**DECISIONS OF THE QUEENSTOWN LAKES DISTRICT COUNCIL**

**CHANGE OF CONDITIONS – SECTION 127**

| <b>RM reference:</b>      | RM210061                                                                                                                                                                              |
| <b>Application:</b>       | Application under section 127 of the Resource Management Act 1991 (RMA) to change conditions 1, 4 and 9(k) of RM161093 (as varied by RM181358) to provide for an amended trail design |

| Drawing No:<br>C1471 | Sheet No:<br>1   | Revision:<br>C | Date Created:<br>April 2020 |

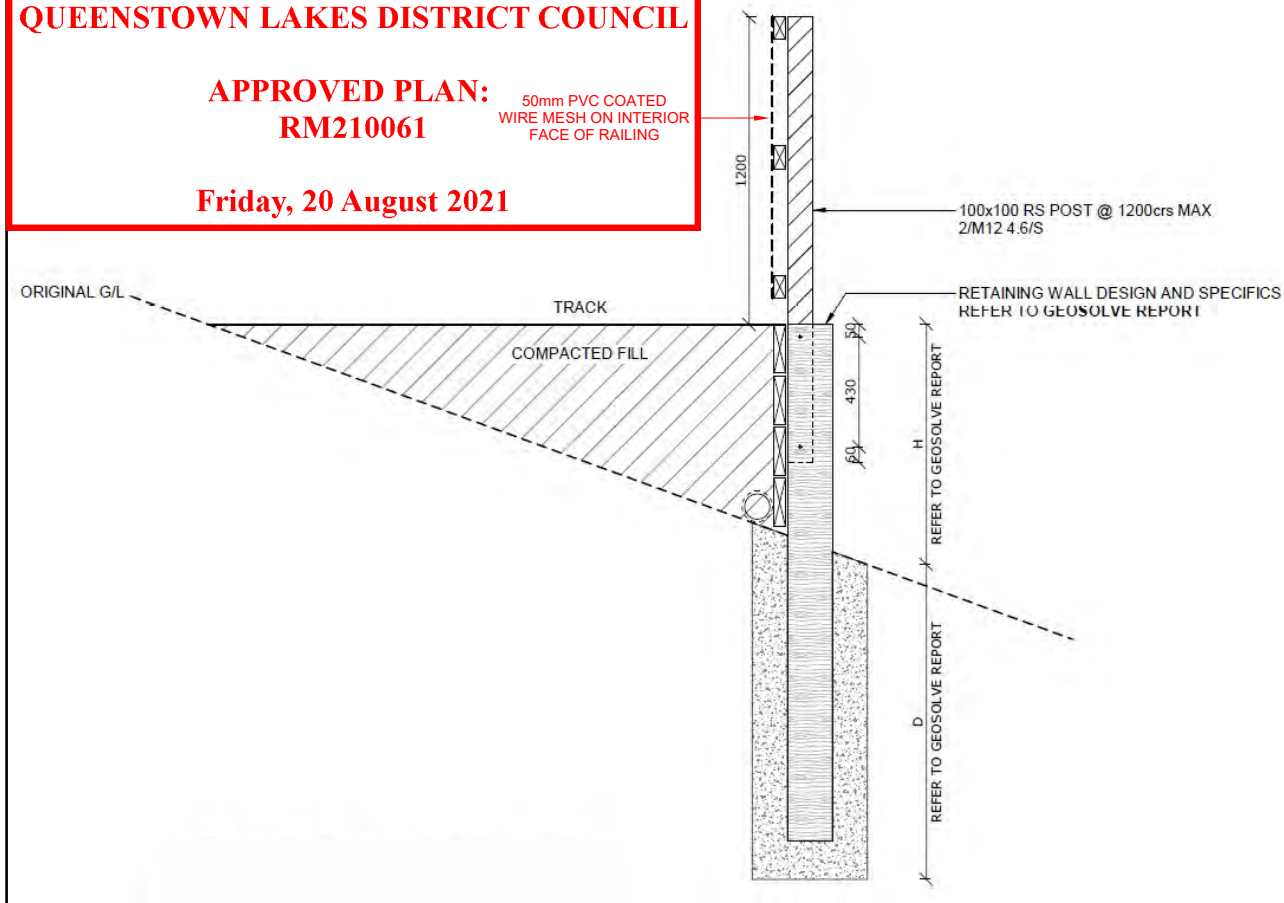
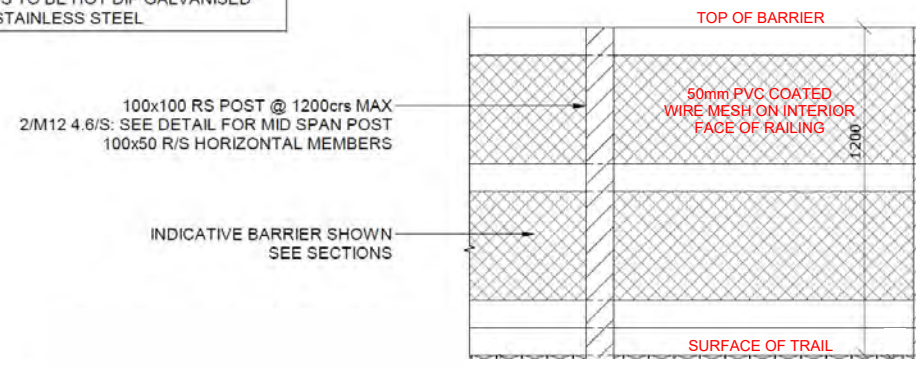
The application states that the revised Trail 1 surface characteristics will consist of a compacted gravel surface with low retaining and timber edging. The proposed steps will be constructed using similar materials to the remainder of the trail, with timber battens along riser edges and compacted gravel between risers. Furthermore, the layout (width, height and depth) of the steps will be in accordance with SNZ HB 8630:2004 and Building Code guidelines. This construction will promote usability and safety, particularly in terms of minimising trip risk and maximising slip resistance. The adjoining timber and wire mesh barrier will also assist usability and safety (being compliant with SNZ HB 8630:2004) and will double as a hand rail (see page 10).

The proposed trail design is as shown and noted on the attached drawings (Drawing No. C1471, Sheets 1-3), and the existing/consented elevated Boardwalk level is depicted on Sheet 2 (the Longitudinal Section, with tabulated height differences) to aid understanding of the change in level between the consented and proposed surfaces. Sheet 3 of the drawing set is an Indicative Perspective View of the proposed curved steps with bicycle wheeling ramp, with reference to the perspective viewpoint shown on Sheet 1. This Indicative Perspective View is a

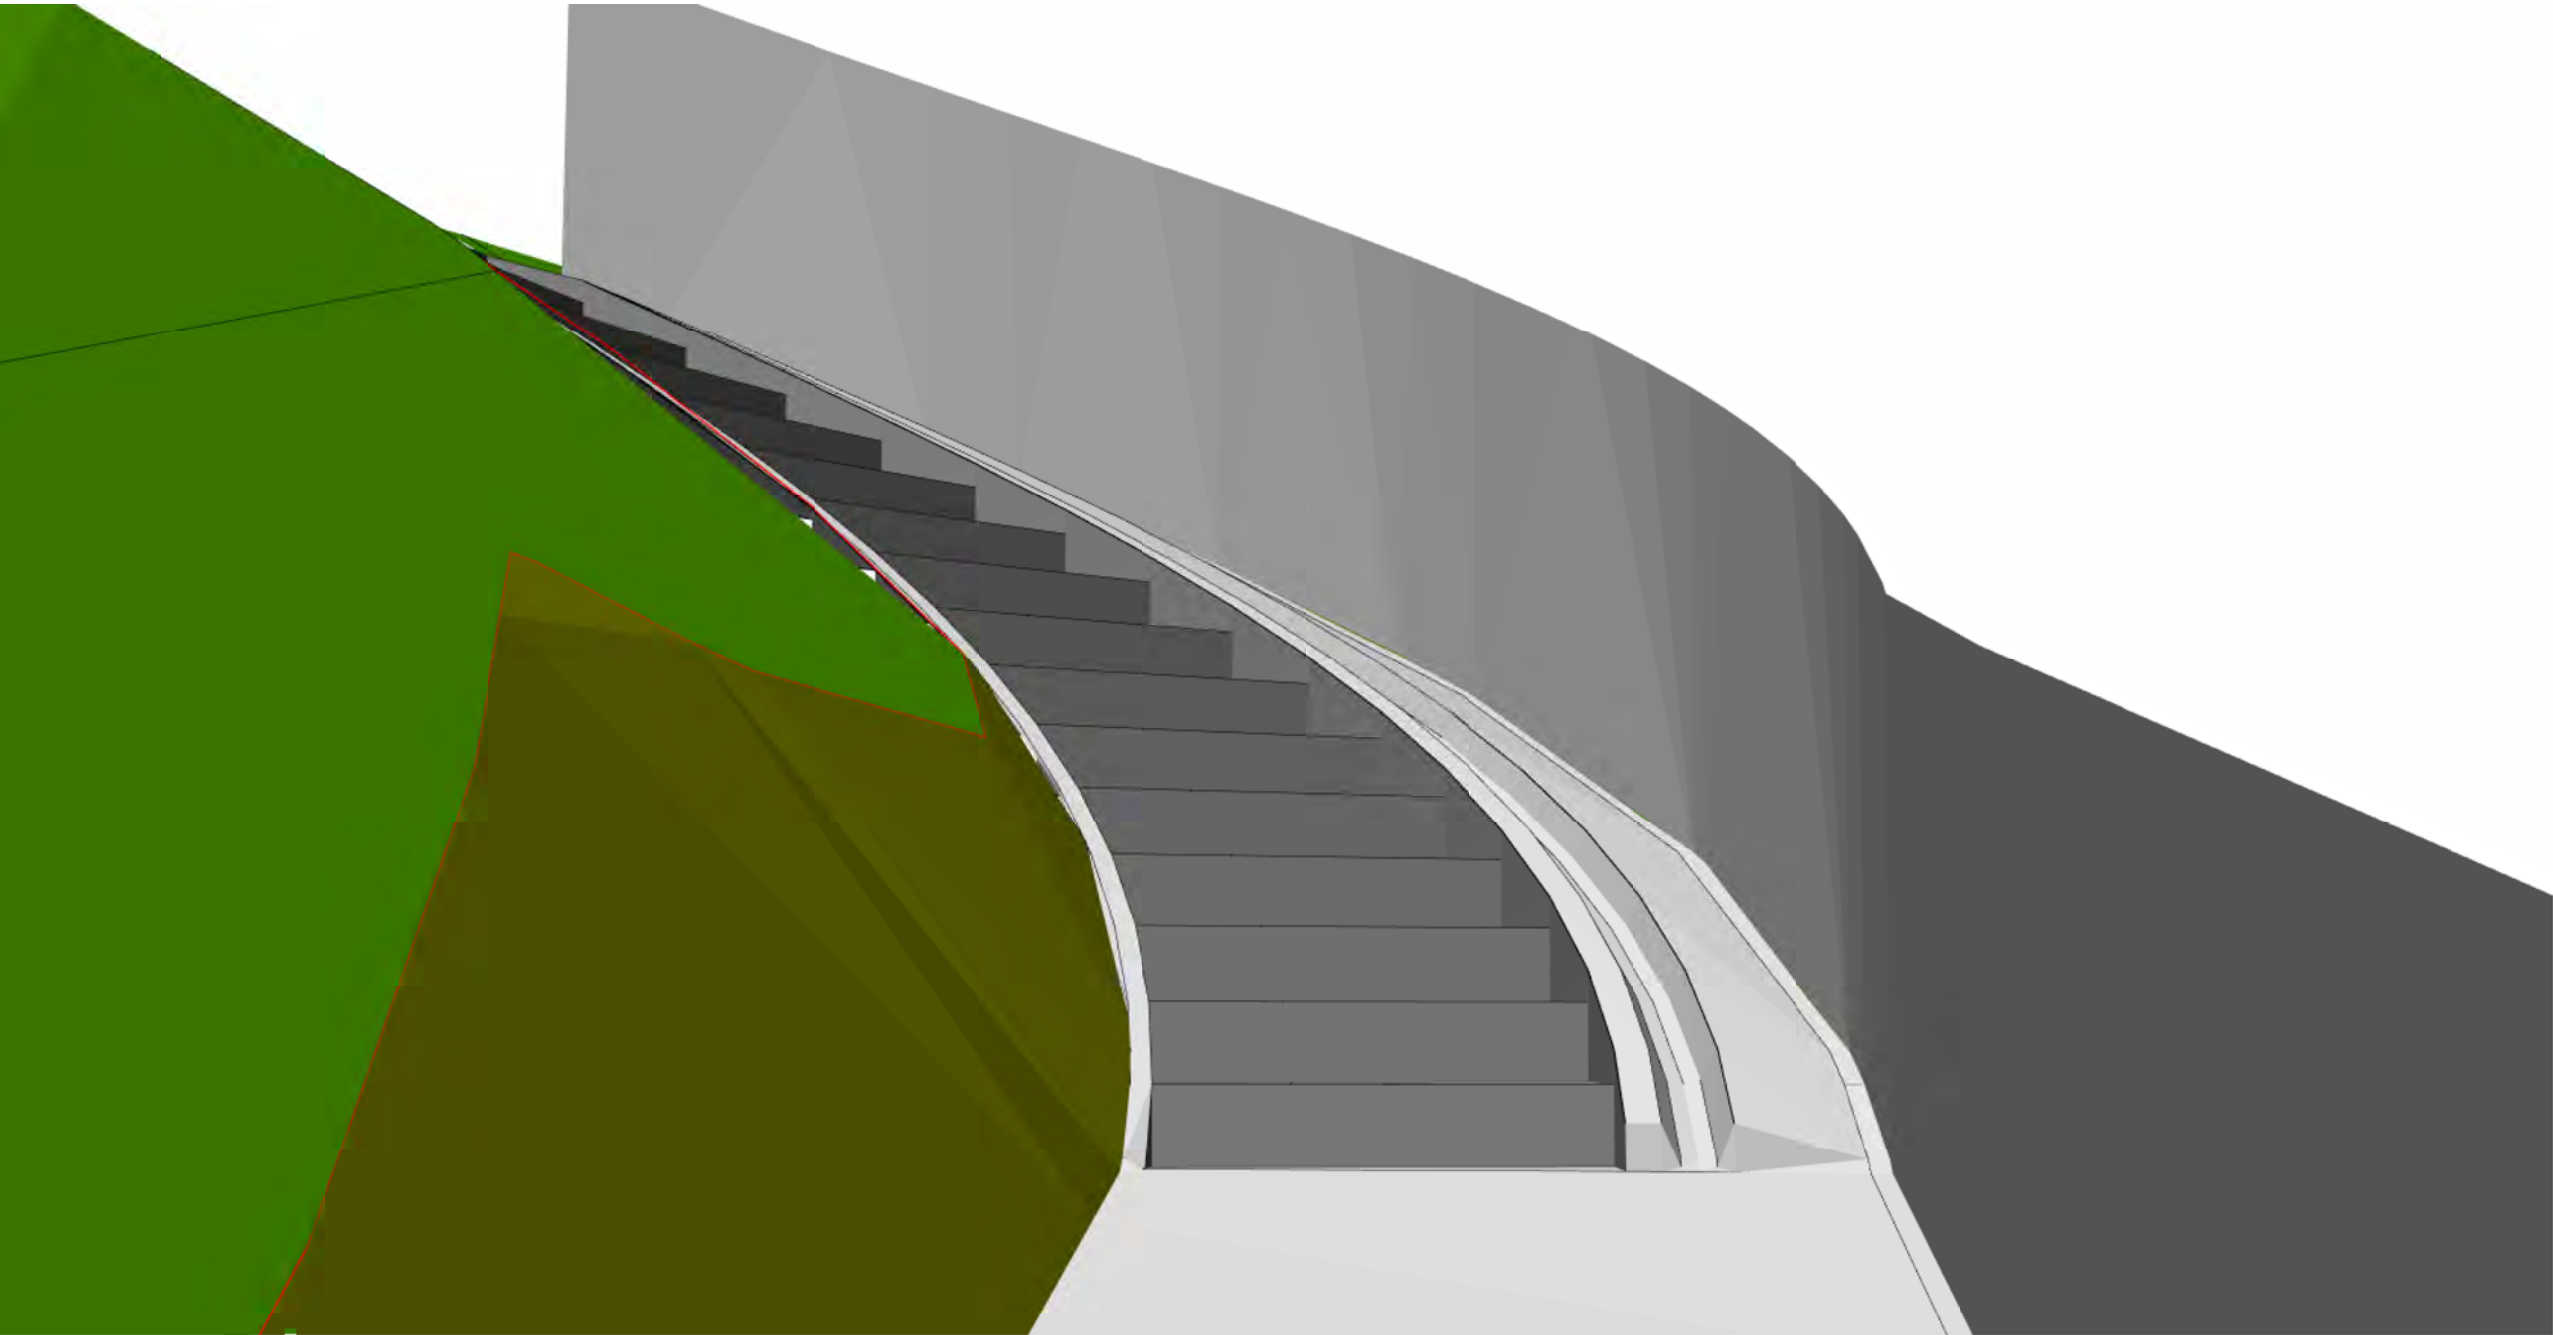
- NOTES:
1. Elevated platform to be removed & gravel trail with low level retaining wall & barrier to be constructed (as constructed elsewhere along Trails 01 & 02) with section of steps & bicycle wheeling ramp
